The 55 details drawn differently in CAD and Revit

Checked against the new drafters' file, 26 October.

55 of the 190 CAD typical details have a Revit version in your templates that is drawn differently. Each page: your CAD detail on the left, the Revit version on the right, what differs, and one answer: CAD is right, Revit is newer (we update CAD from it), or both wrong.

CAD: KOR-D504-DET 07 - DOWNTURN DETAIL

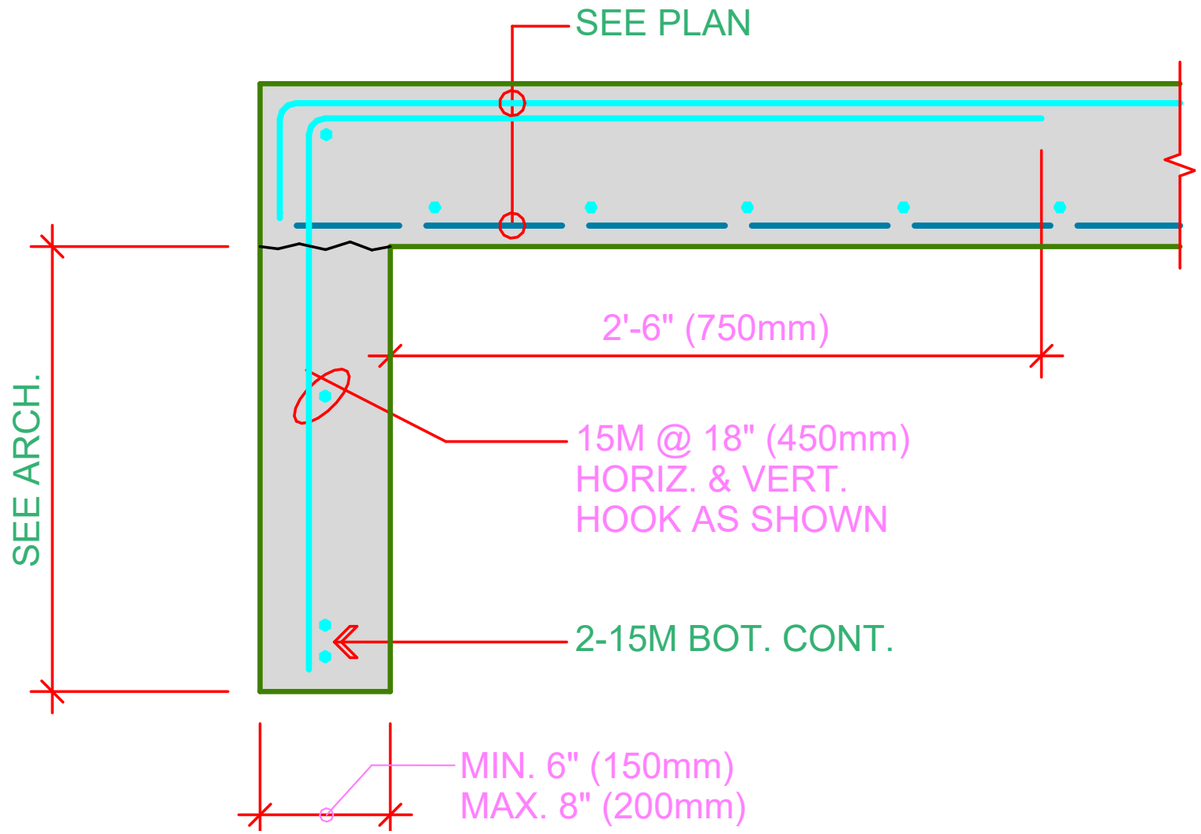
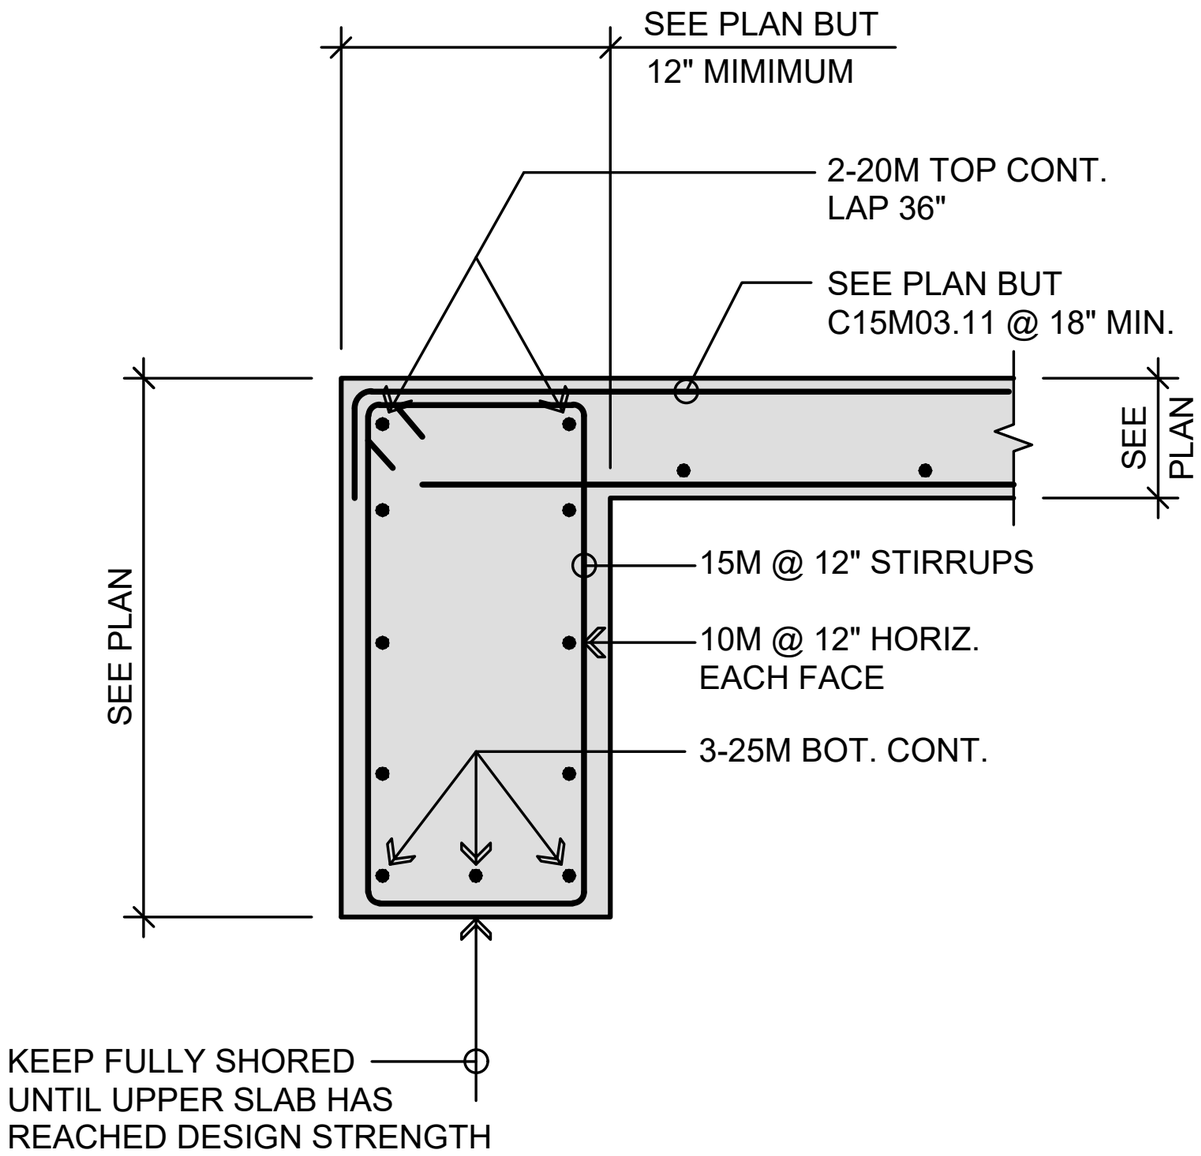
What differs: Same 2'-6in slab-edge downturn idea, but the CAD uses 15M @ 12in each face and a wider section; '1E1.04_13_TYPICAL DOWNTURN' uses 15M @ 18in.

CAD: KOR-D504-DET 08 - DOWNTURN DETAIL

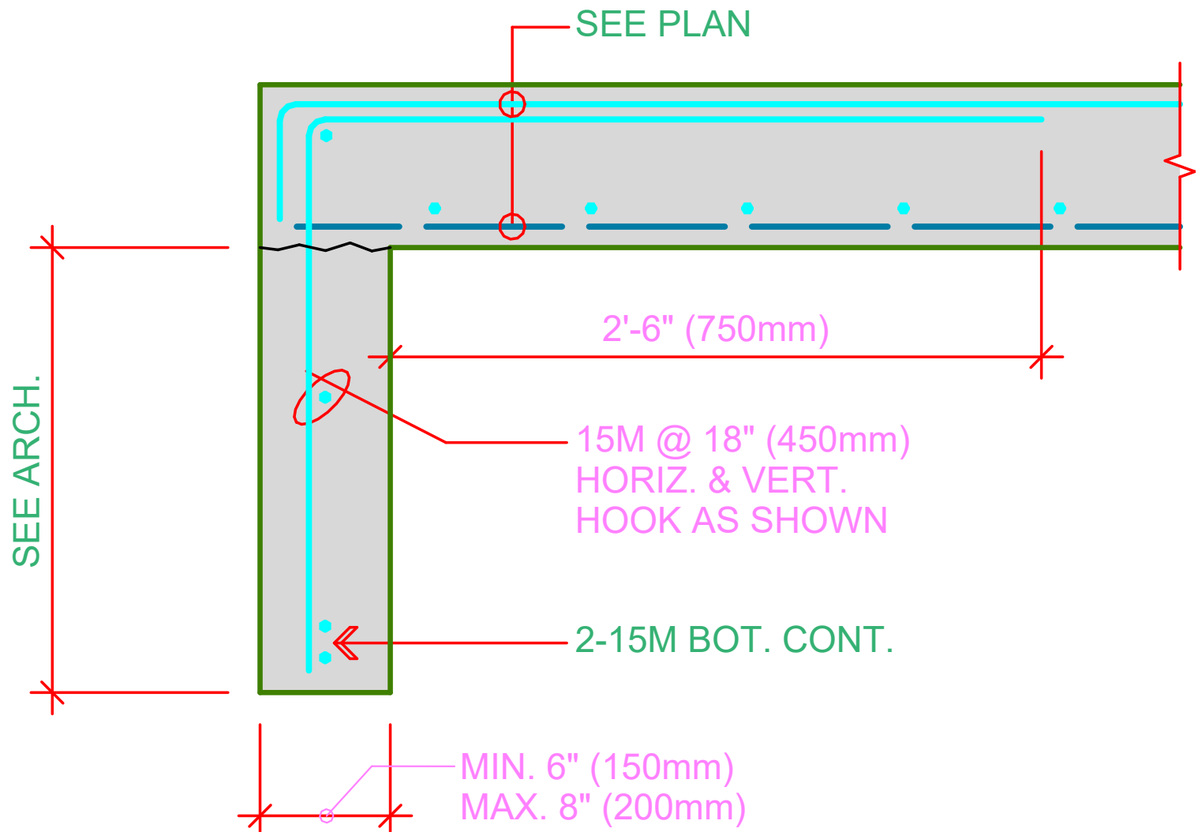
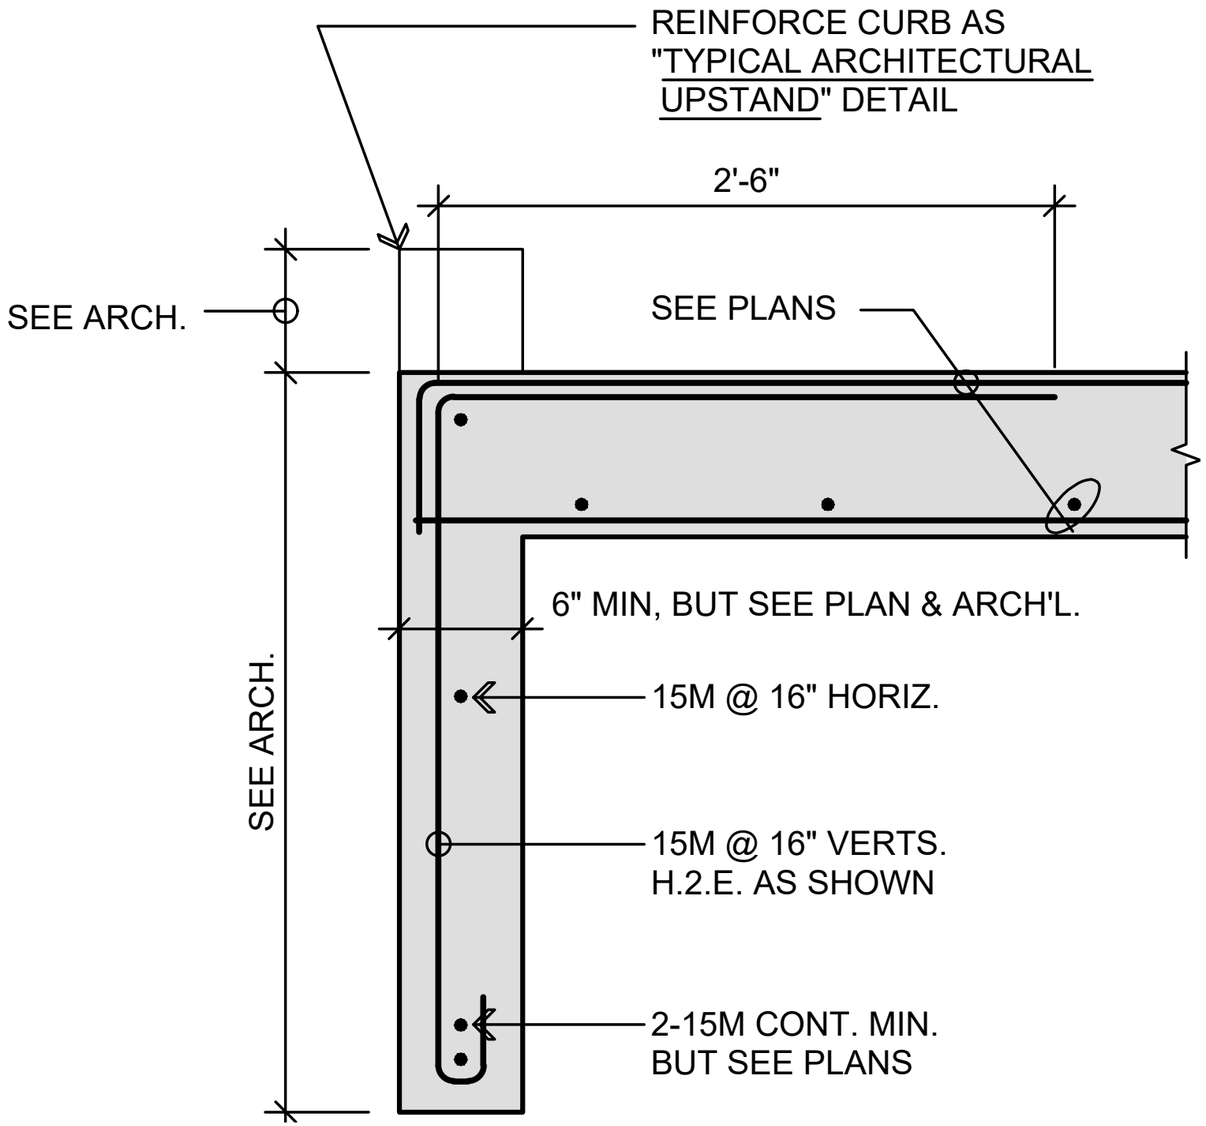
What differs: CAD is a stirruped downturn beam (3-25M bot, keep shored); '1E1.04_13_TYPICAL DOWNTURN' is a plain thin downturn wall.

CAD: KOR-D504-DET 09 - DOWNTURN DETAIL

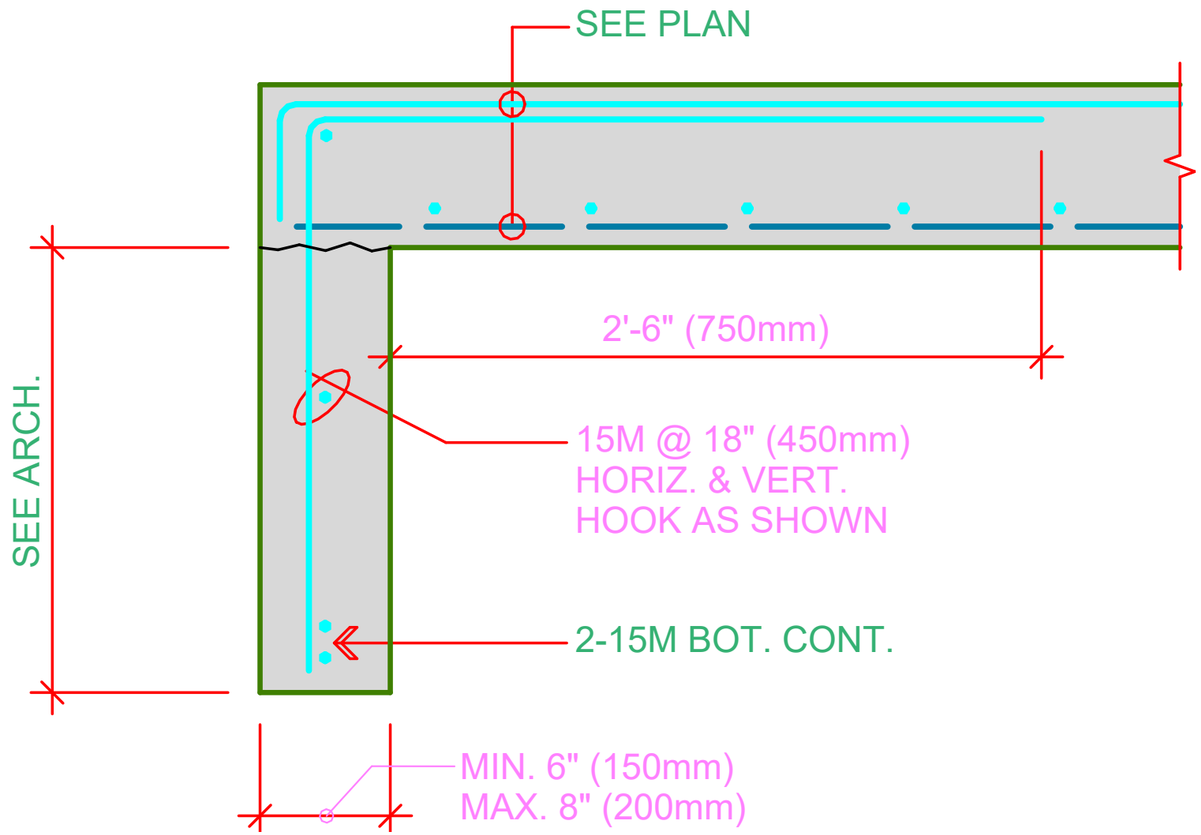
What differs: Closest match: same 2'-6in downturn with 2-15M bot cont, but the CAD has 15M @ 16in horiz/vert where '1E1.04_13_TYPICAL DOWNTURN' has 15M @ 18in, plus a curb/upstand callout.

CAD: KOR-D504-DET 10 - BALCONY DETAIL

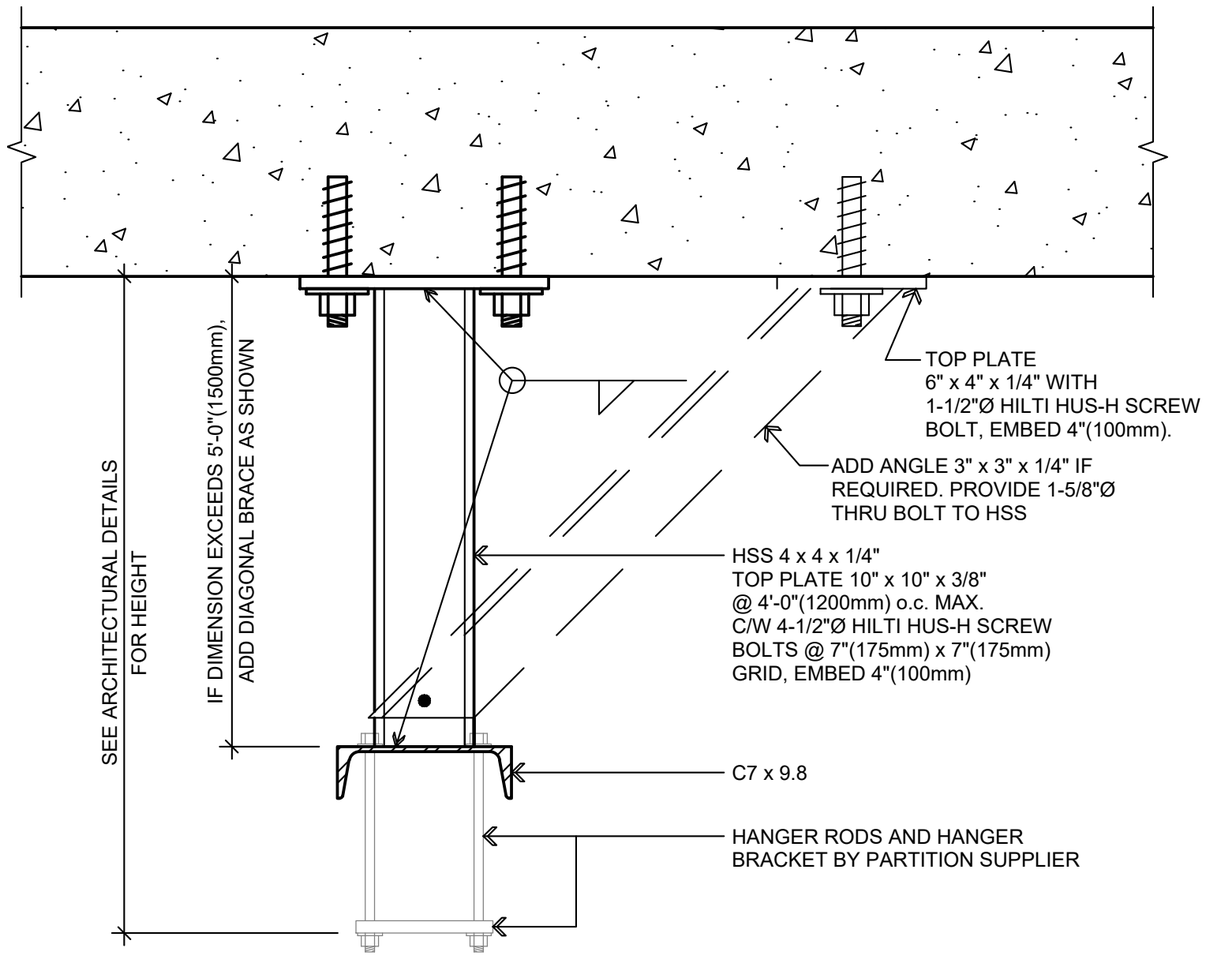
What differs: Both are balcony slabs thickened for drain slopes; the CAD has a 7 1/2in slab and 1 1/2in max thickening without the curb and guardrail hook-bar note '1E1.04_7_TYPICAL BALCONY DETAIL' shows.

CAD: KOR-D505-DET 03 - FOLDING PANEL HANGER DETAIL

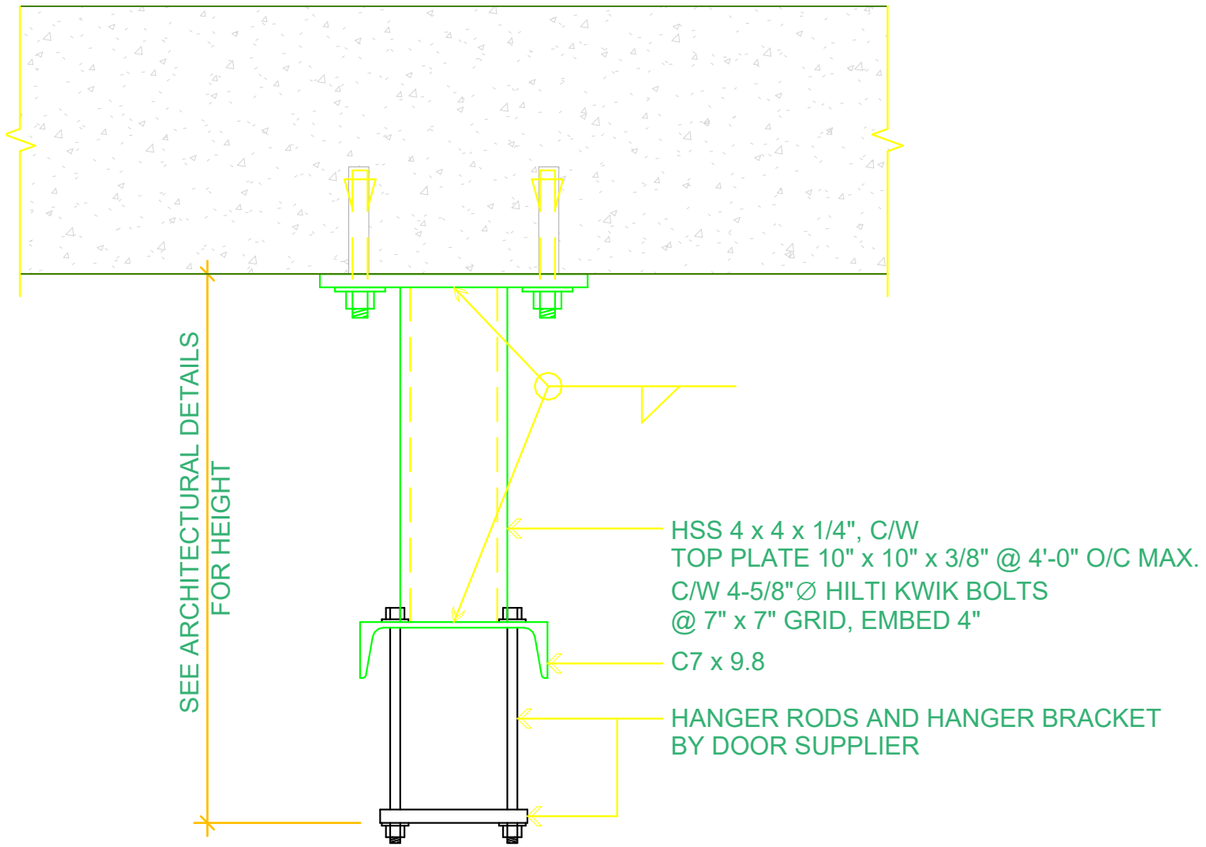
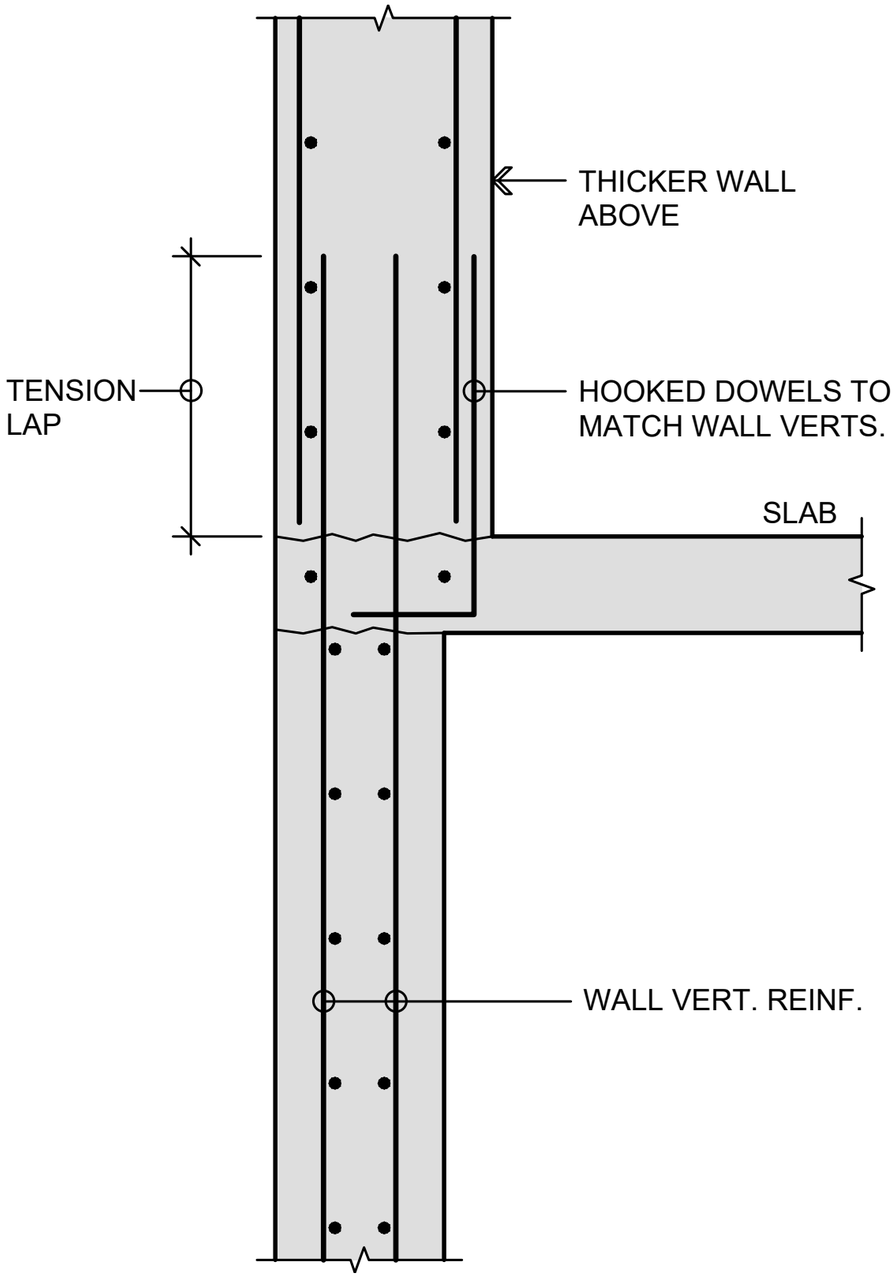
What differs: Same folding panel hanger, but the CAD adds a diagonal angle brace and uses Hilti HUS-H screws @ 6ft for a 15 psf door; 'D5.01_12_FOLDING PANEL HANGER DETAIL' has Kwik bolts @ 4ft for 20 psf and no brace.

CAD: KOR-S302-DET 07 - TYPICAL WALL AND ZONE VERT REINFORCING DETAIL THICKNESS CHANGES

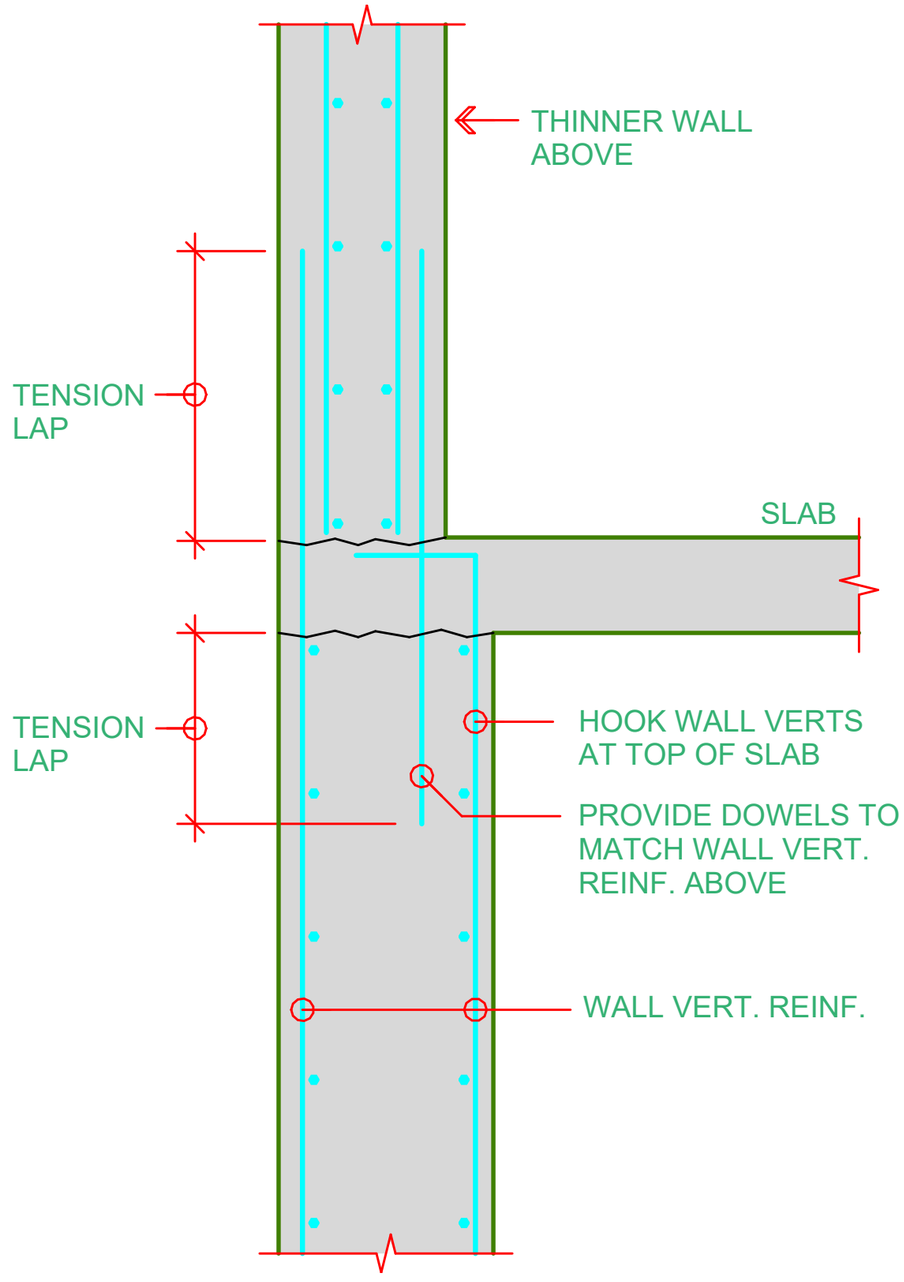
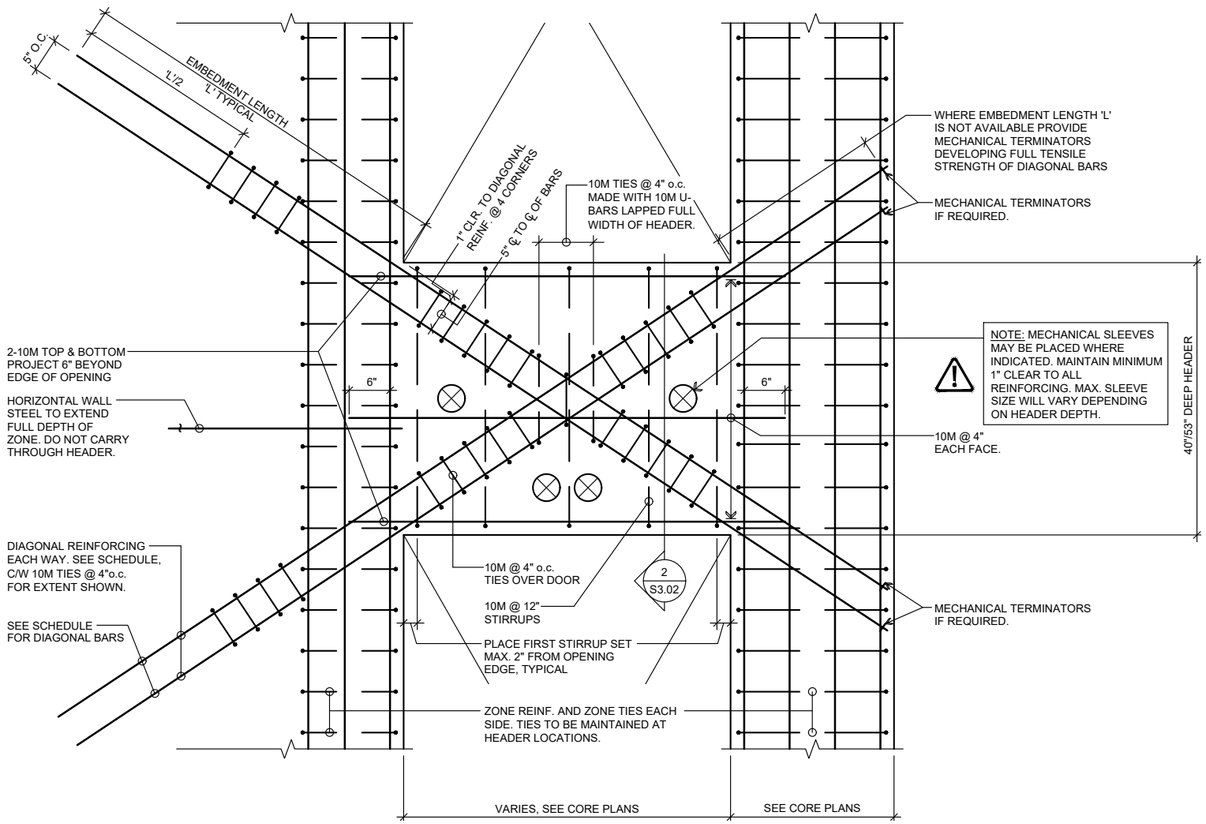
What differs: CAD is the THICKER-wall-above case with hooked dowels to match the wall verts and one tension lap; '1E3.05_6_TYPICAL WALL AND ZONE VERT REINFORCING DETAIL WHERE WALL THICKNESS CHANGES'/'D3.05_6_TYPICAL WALL AND ZONE VERT. REINFORCING DETAIL WHERE WALL THICKNESS CHANGES' are the thinner-wall-above case.
